ISO
14229-1

AMENDMENT 1
2022-10

Road vehicles — Unified diagnostic services (UDS) —

Part 1: Application layer

D.2.1,

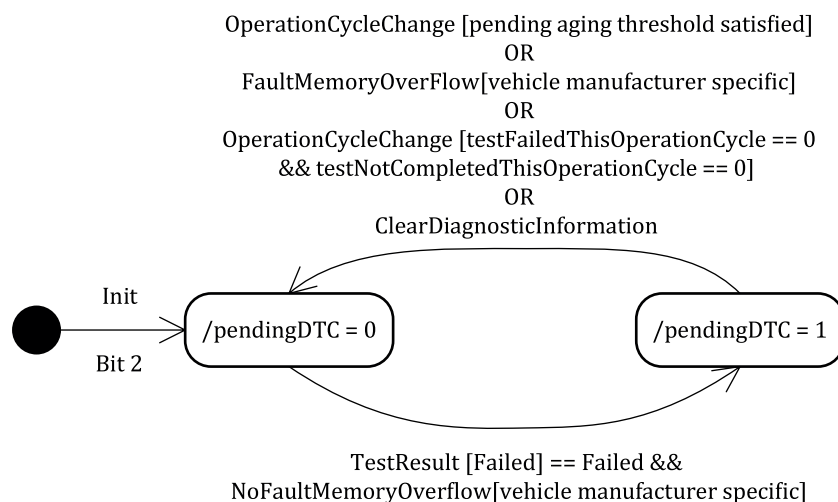
Replace the list item:

- **Confirmation Threshold:** The confirmed status of a failure is defined as a test having reported 'Failed' for this test for a given number of operation cycles where the test has run to completion. Typically for non-OBD use cases the threshold for operation cycles is defined as one. For OBD use cases this threshold is typically greater than one. Implementations may use a Trip Counter (see Figure D.9) as a trigger for changing the confirmed status from 0 to 1. The Trip Counter counts the number of operation cycles (driving cycles) where a malfunction occurred. If the counter reaches the threshold (e.g. 2 driving cycles) the confirmed bit changes from 0 to 1.

with the following:

- **Confirmation Threshold:** The confirmed status of a failure is defined as a test having reported 'Failed' for a given number of operation cycles where the test has run to completion. Typically for non-OBD use cases the confirmation threshold for operation cycles is defined as zero. For OBD use cases this confirmation threshold is typically greater or equal than one. Implementations may use a trip counter (see Figure D.9) as a trigger for changing the confirmed status from 0 to 1. The trip counter is incremented at the end of an operation cycle if testFailedThisOperationCycle is 1 and counts the number of completed operation cycles where a malfunction occurred. If test result reported a value of "failed" and the trip counter has reached the confirmation threshold, then the confirmed bit changes from 0 to 1.

D.2.3, Figure D.4

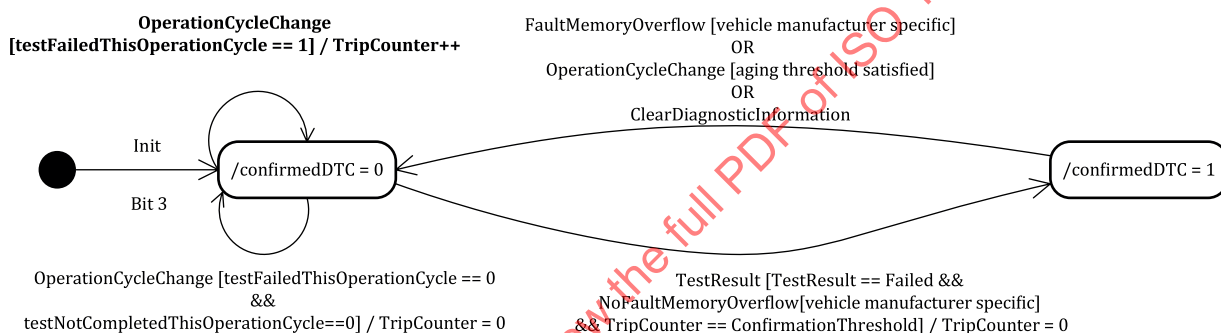
Replace Figure D.4 with the following:

D.2.4, Figure D.9

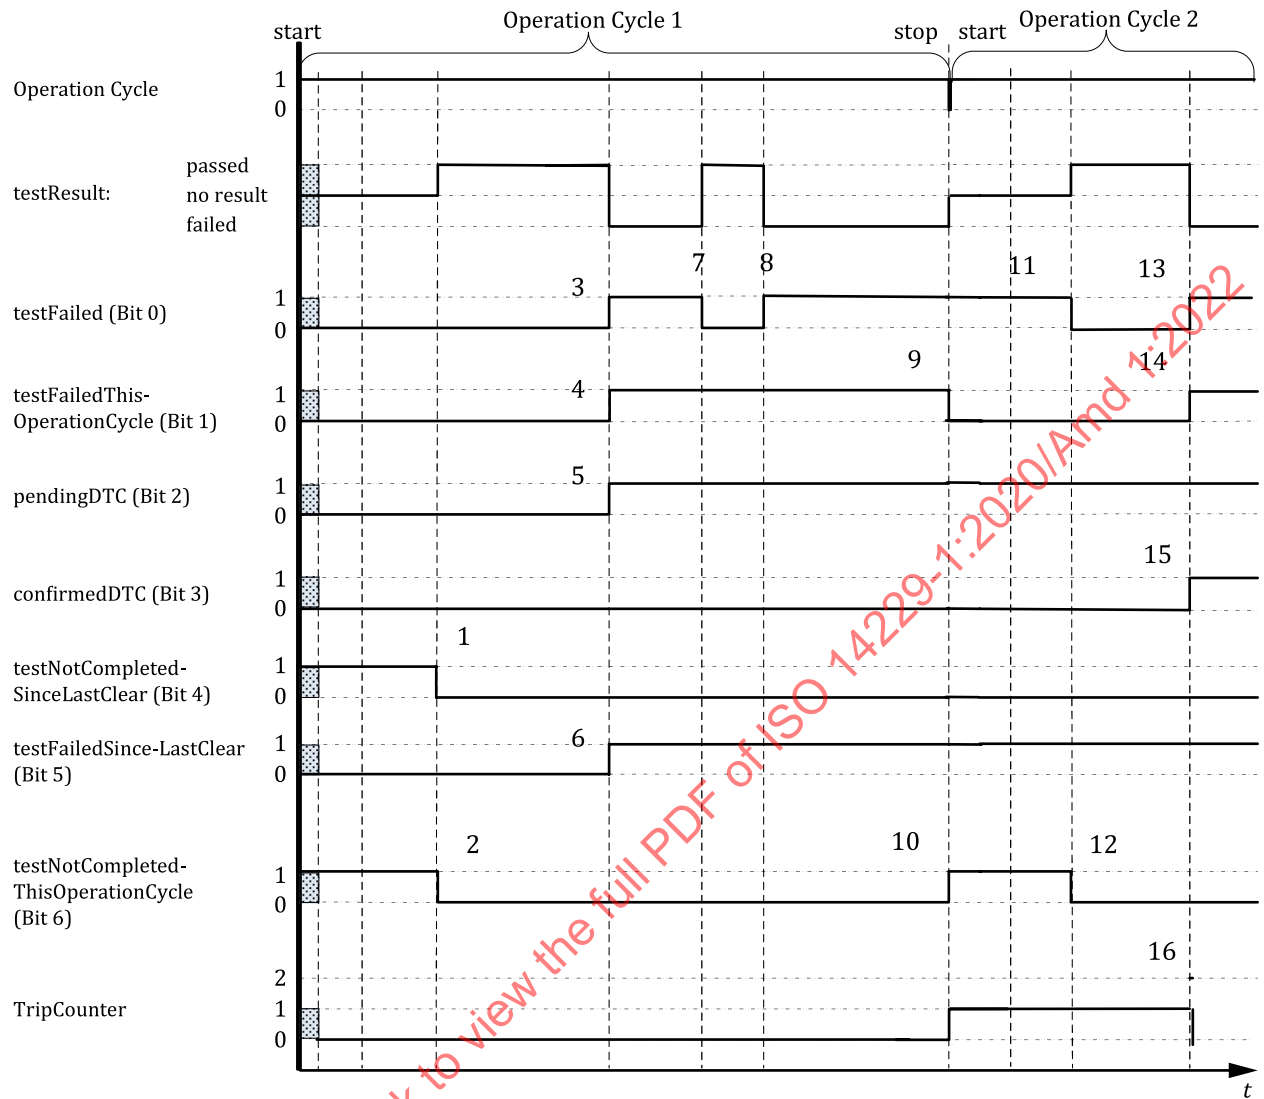
Replace Figure D.9 with the following:

Replace description of key 16 with "TripCounter is reset to '0' when the DTC status changes to confirmedDTC according to Figure D.4."

D.6, Figure D.10

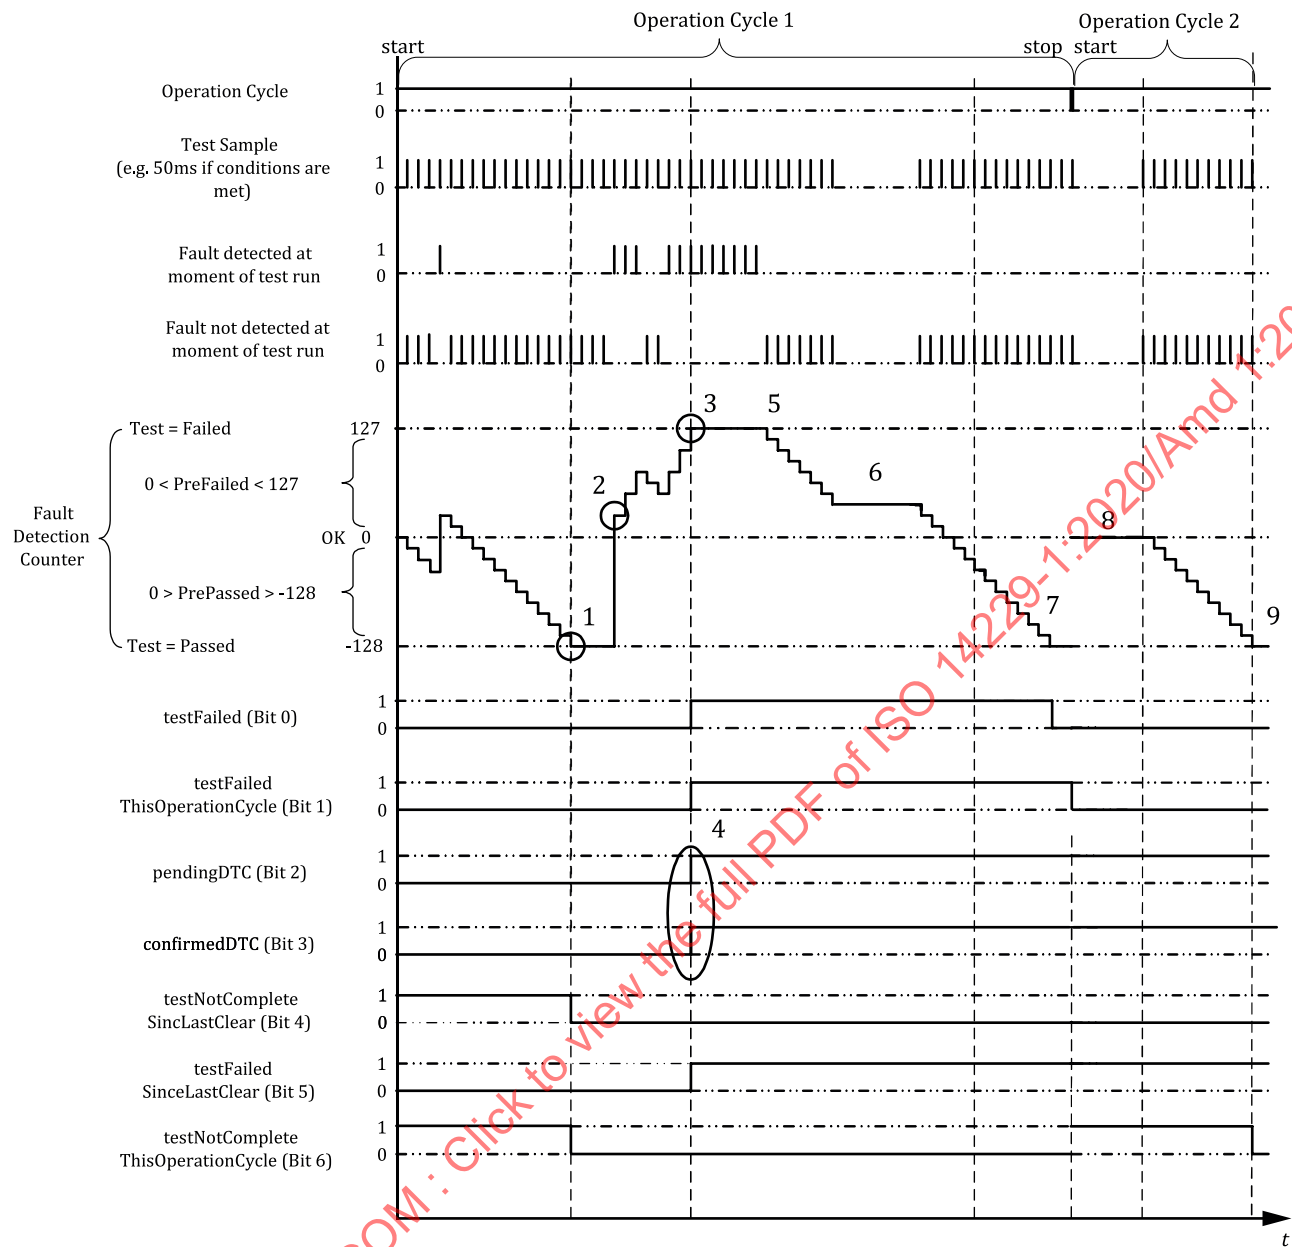
Replace Figure D.10 with the following:
